CENTERVILLE CITY PLANNING COMMISSION AGENDA

7:10 1. Public Meeting - Renatus Office Building Addition - 1312 W 75 N - Final Site Plan & Parking Modification

7:30 2. Public Hearing - Sheffield Downs at ~274 E Pages Lane -- Zoning Map Amendment, Conceptual Site Plan, Conceptual Subdivision

**CENTERVILLE
PLANNING COMMISSION
Staff Backup Report
7/11/2018**

Dumpster Enclosure

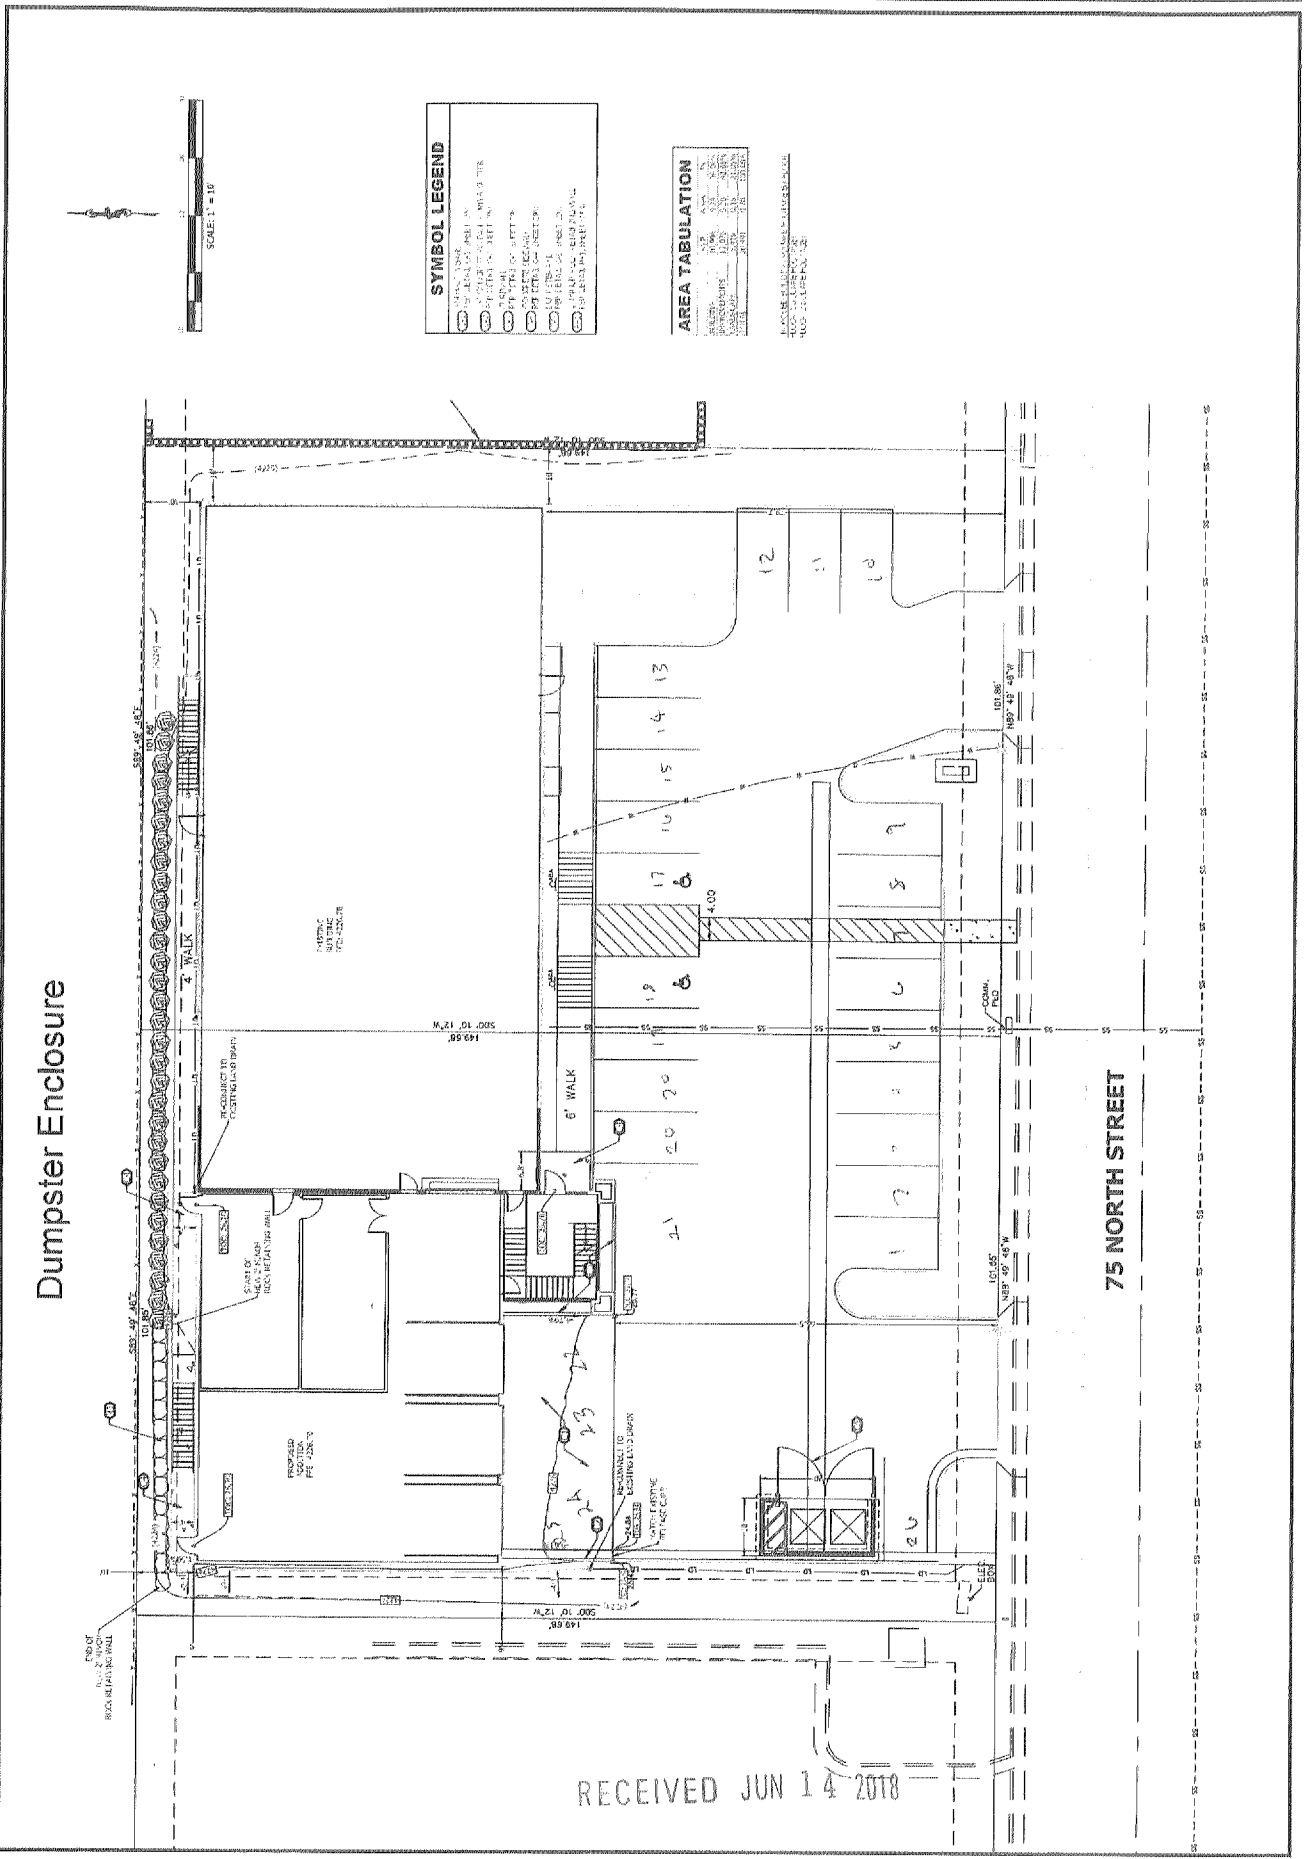
Staff Response: The dumpster complies with 12.51.110 that states that the trash receptacle must be at least six feet in height, provides complete visual screening of the receptacle, and is compatible in material and color with the main building.

Note: The dumpster has moved since the Conceptual Site Plan. This change eliminates additional stalls, bringing the total count down to 26, according to Staff calculations on the Dumpster Enclosure site plan at submitted on June 14, 2018.

ELEVATIONS
Drawing No. RA-200
REV

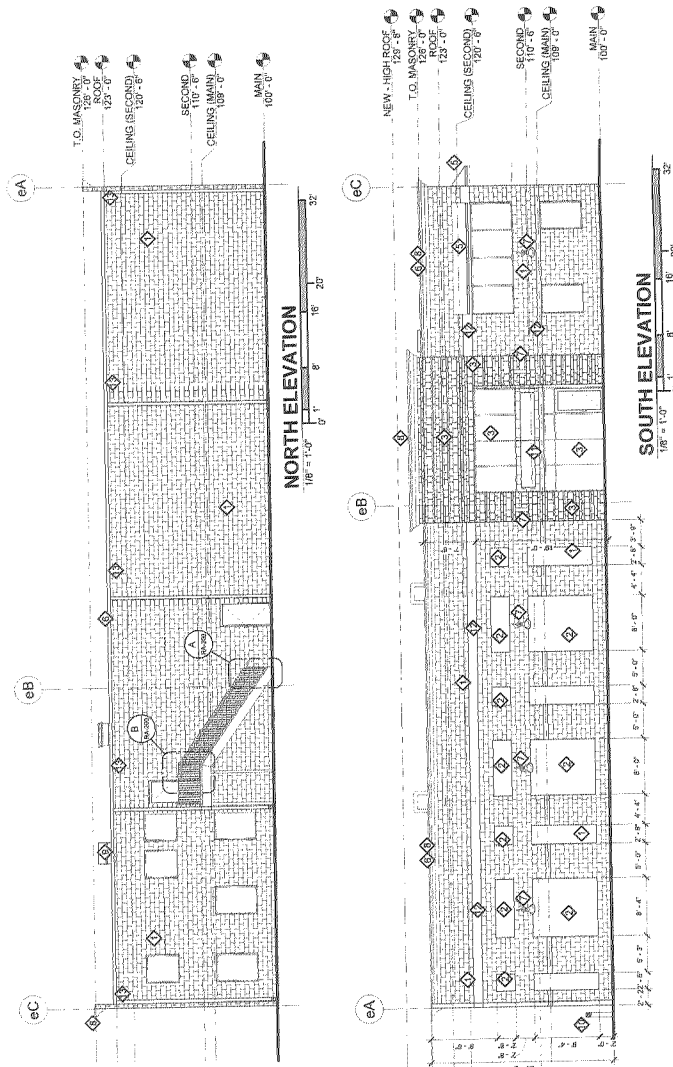
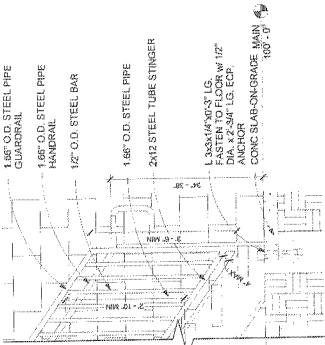
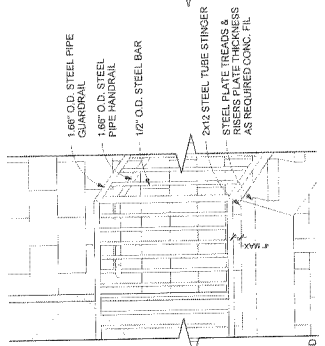
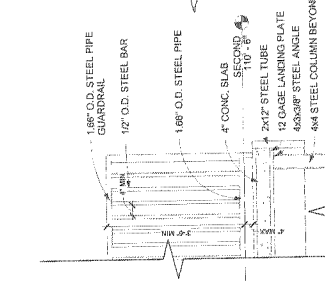
Staff Response: Architecture elevations match the existing building in style and materiality, made with the majority natural split face block and stone along the pillar corners. [Refer to attached elevations]

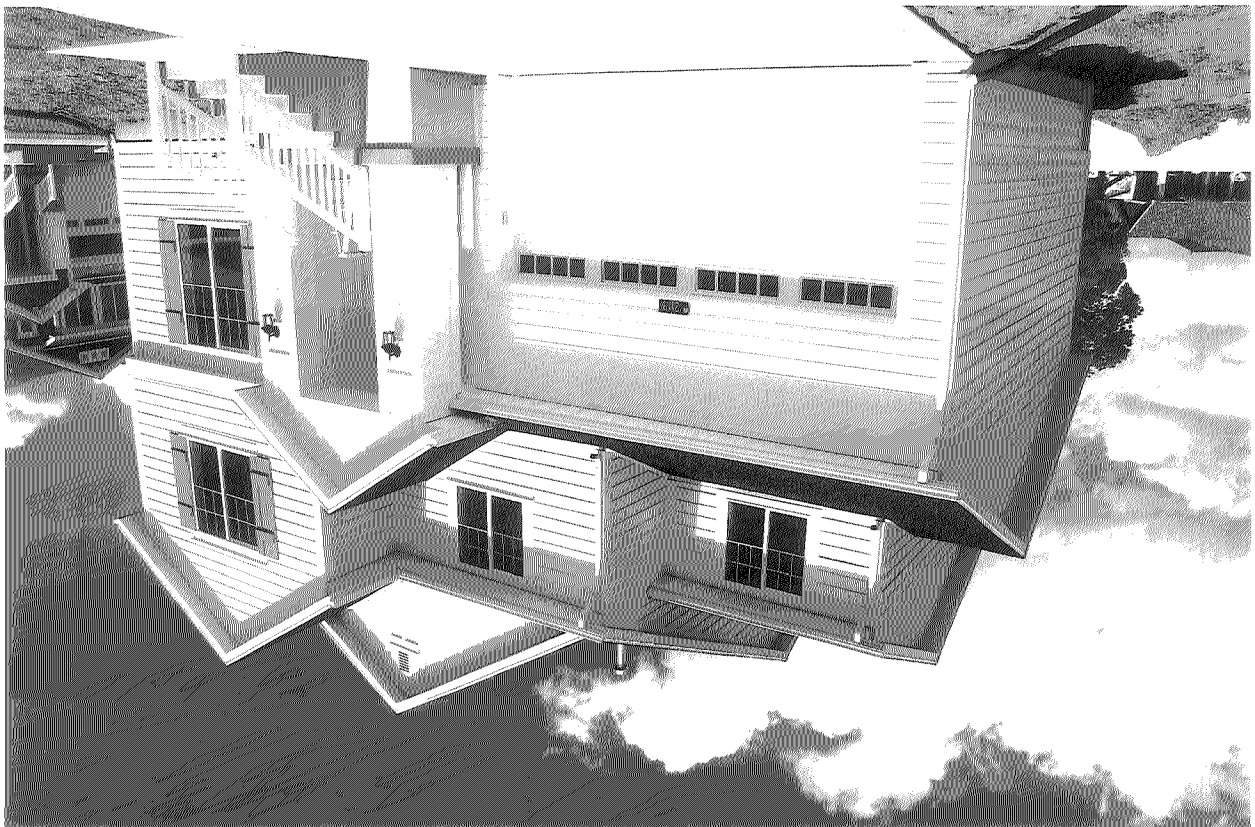
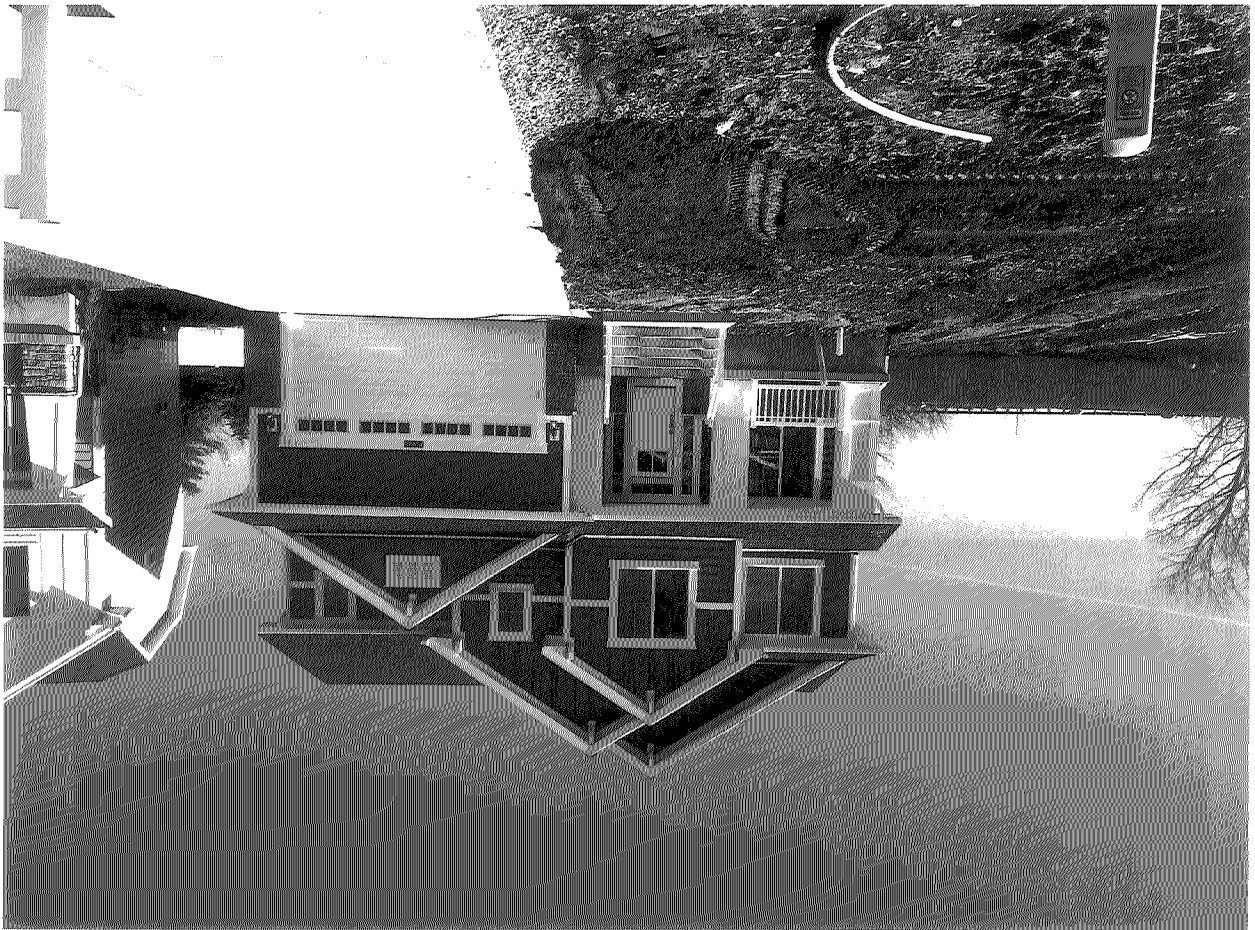
Staff Comment: [DOES NOT COMPLY] If the R-M rezone is approved, the underlying setback along the southern lots (lots 22-33) needs to be increased from 15 feet to 20 feet and Lot 22 needs to be increased from 5 feet to 8 feet in order to meet the track perimeter requirements.

Staff Comment: [LIKLEY COMPLIES] The submitted plans appear to comply with the private roadway dimensions, and visitor parking (24 stalls/ .72 stalls per dwelling). As part of any subdivision or development approval, the construction drawings will need to be prepared and approved by the City to ensure compliance with applicable standards and specifications.

Staff Comment: [CONFORMS] The submitted plans depict single-family lots located along private roadways. Visitor parking is provided as part of the design of the Open Space element rather than solely relying parking on the private street.

Suggested Motion for the Planned Development Overlay Request for the SHEFFIELD DOWNS DEVELOPMENT located at 224 East Pages Lane: I hereby make a motion for the Planning Commission **TABLE** the matter and direct the applicant to further address the following:

1. The petitioner shall address the Southeast Neighborhood Plan policy matter regarding the current market demands and the commercial viability of the area. Why is it time to consider allowing residential re-development?
2. The petitioner shall prepare a project specific Architectural Plan that includes a “materials and colors story-board re-addressing the Southeast Neighborhood and PDO expectations that “*dwellings are to be designed with elements and materials that are weather resilient and have design elements with a robust architectural character.*” The Architectural Plan shall consider the following:
 - a. Greater use of the heavier architectural elements. Brick and stone improve the durability of the home exterior.
 - b. Address the use of these architectural elements on all sides of the buildings.

- c. Provide development schedule indicating the approximate date when construction or its stages can be expected to begin and be completed.
- 5. The petitioner shall modify, as needed, the Conceptual Subdivision Layout to reflect the changes being proposed or suggested.
